3581 SR 970

WLC PROPERTY HOLDINGS LLC
SITE PLAN

From: [Josh Mitchell](#)
To: [Jeremy Johnston](#); "Ed Sewall"
Cc: [Spencer Parr](#); [Kelly Bacon \(CD\)](#)
Subject: Re: Swiftwater Storage CUP and Residential Building Application Parcel 15445
Date: Wednesday, June 9, 2021 7:01:43 PM
Attachments: [20182-Final.pdf](#)

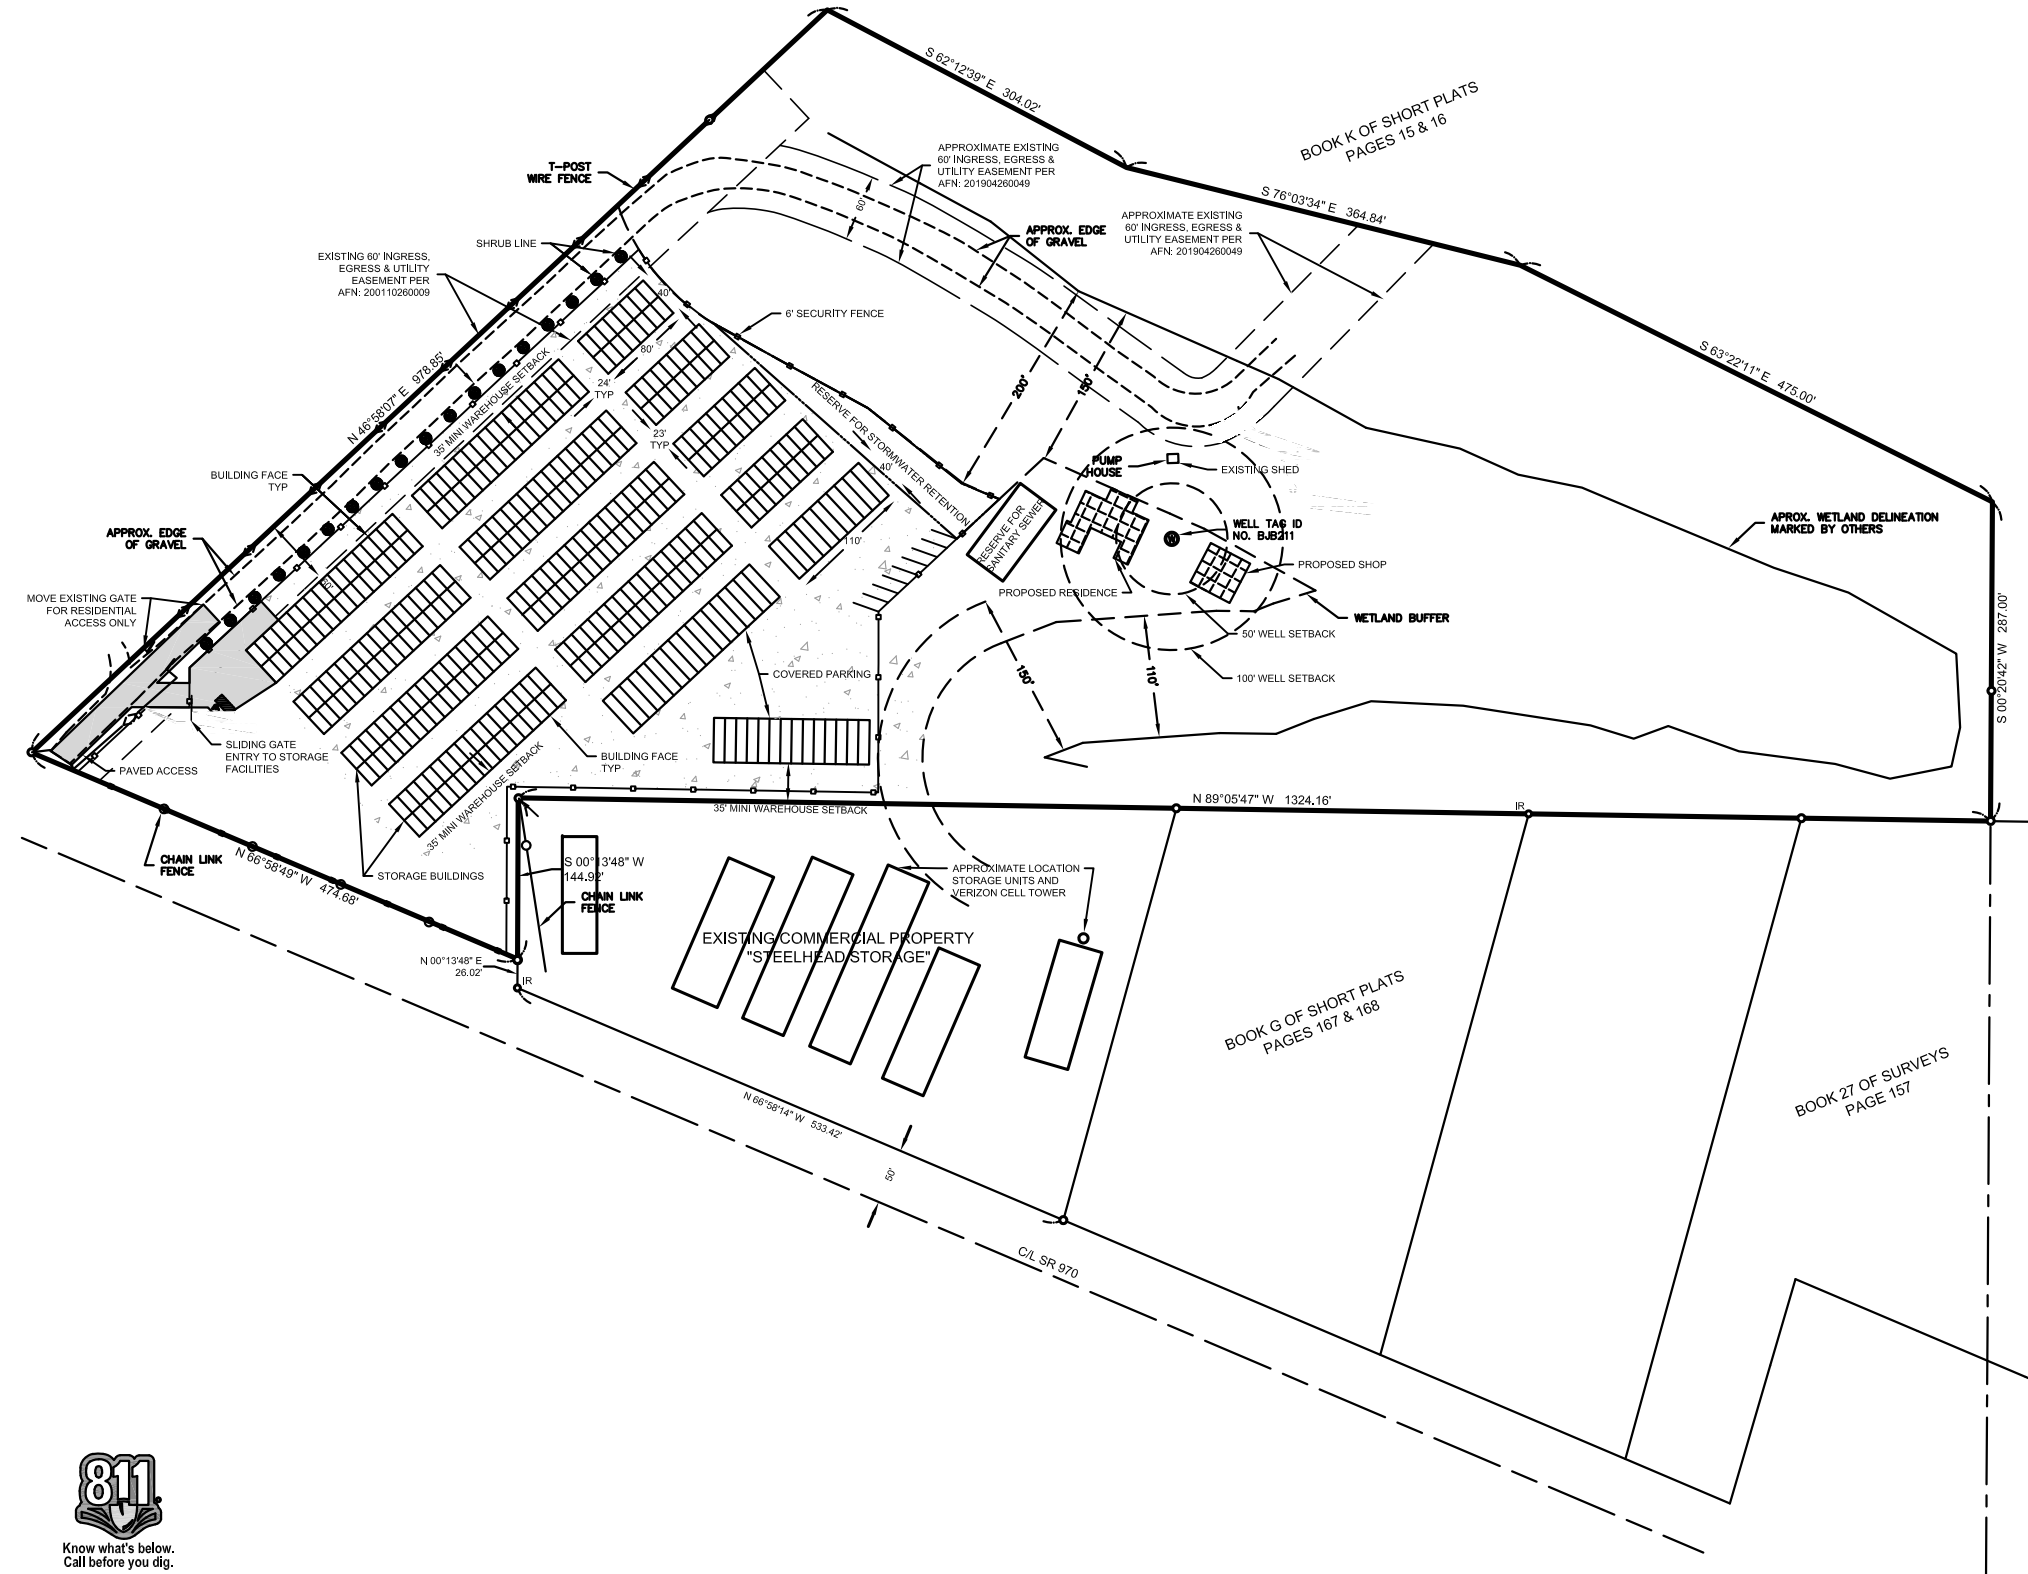
Please note that all proposed commercial construction, including even the storm water retention placement will be at least 200+ feet from the Category II wetlands along our northern boundary and at least 150+ feet from the Category III wetlands at the southern boundary.

Similarly, all proposed residential construction is at least 150+ feet from the northern wetlands and 110+ feet from the southern wetlands. Our residential septic fields are located more than 100 feet from the well.
